Subject: J-Coach Rear Window Trim Panel Retention			
Field Change Program: Procedure	Procedure Number: 03-276	Revision: A	Date: 01/16/2020
Coach Section: 03-Body	P/N: 03-16-7338		Type: Product Improvement

MCI observed that the dual lock tape retaining the rear window trim panel on the J4500 is coming loose. This procedure outlines steps to add mechanical fasteners to secure the panel.

Rear Window trim
03-16-7338

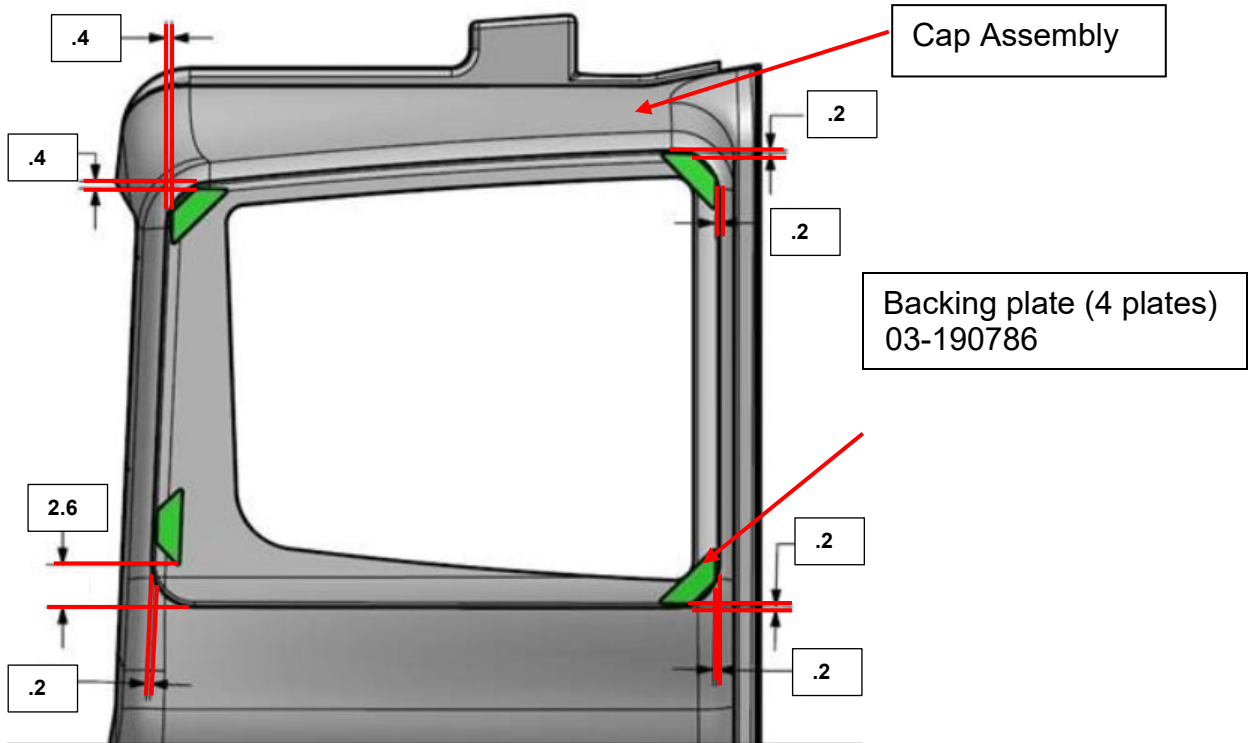
Remove the rear window trim panel and save.

Clean the bonding surfaces of the components being bonded using 23-05-0005. Allow 5 minutes for the alcohol to flash off. Apply .25" dia bead of 23-02-0005 in a zig-zag pattern to the bonding surfaces and clamp until the methacrylate is fully cured.

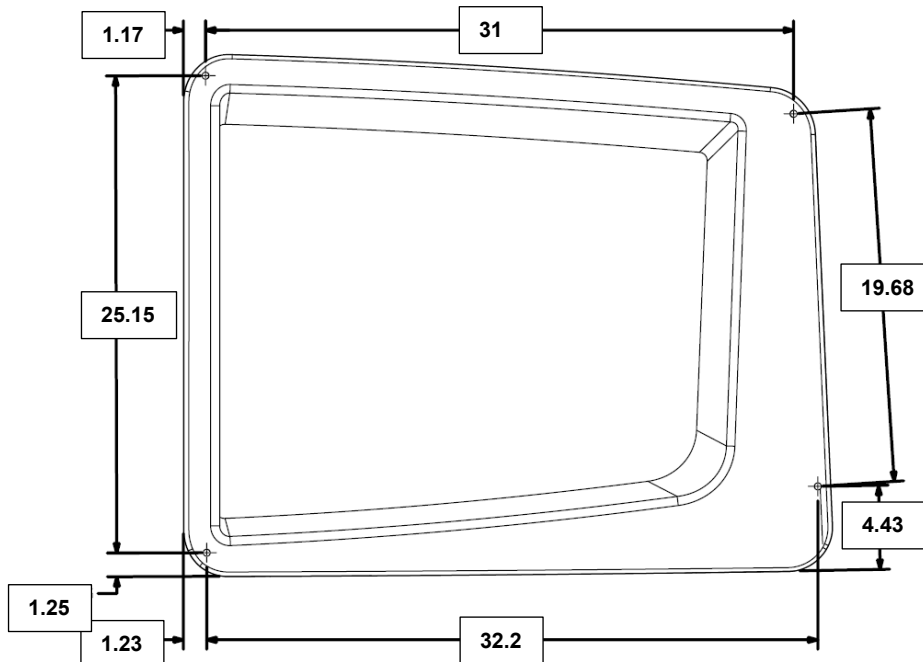
Drill four holes of .136" dia through the window trim, the cap assembly, and the backing plate using #29 drill bit.

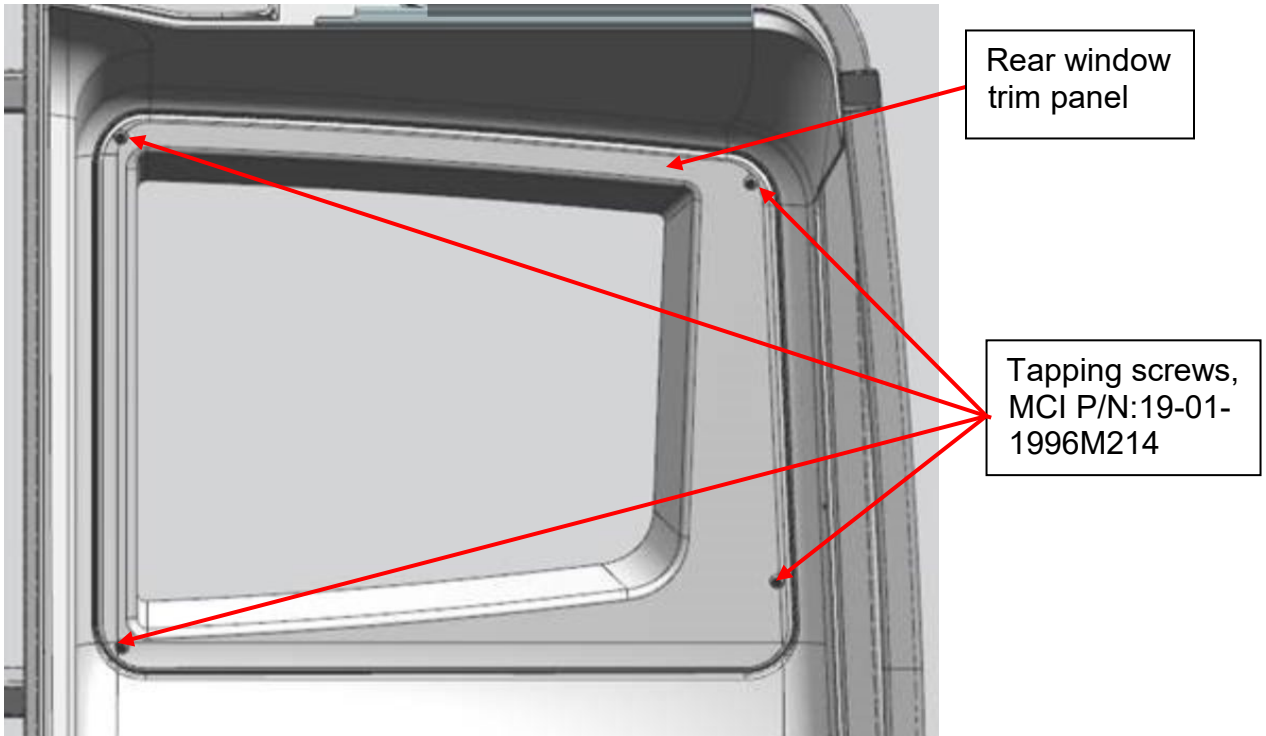
Secure the rear window trim panel to the rear window panel assembly using four tapping screws, MCI P/N:19-01-1996M214.
